Schindler Ltd.
Field Quality & Excellence

From Steven Reynolds
Telephone 01932 758 100
E-mail tech.support@gb.schindler.com
Reference no. FI 379/IG/FL
Date 04/07/2011
Subject **Schindler Smart MRL: Potential Problem with Counterweight Upper Yoke**

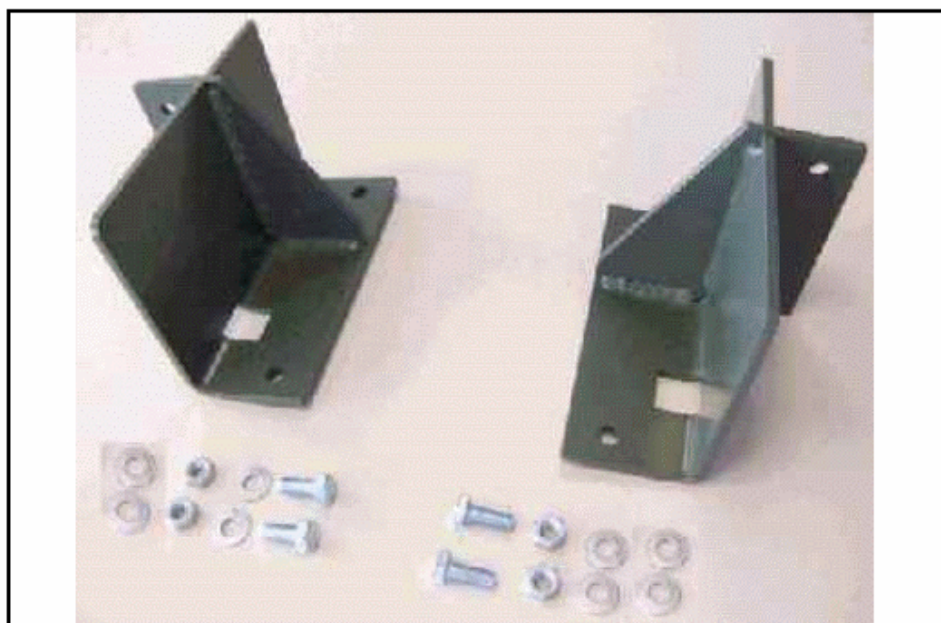
We have identified a potential problem with the counterweight frames on Schindler Smart MRL lifts with rated loads of 320, 450 and 630 Kg manufactured before Feb. 2001, i.e. counterweight frames with no reinforcement welding on the upper yoke.

Some of these counterweight frames may experience cracks and tears where the uprights are attached to the upper yoke, potentially leading to a mechanical failure of the upper yoke.

Check all relevant counterweight frames for cracks and tears where the uprights are attached to the upper yoke. Request a reinforcement kit (below) and installation instructions for all affected installations (regardless of whether cracks or tears are found) by completing and returning the enclosed reporting form to Schindler Ltd.
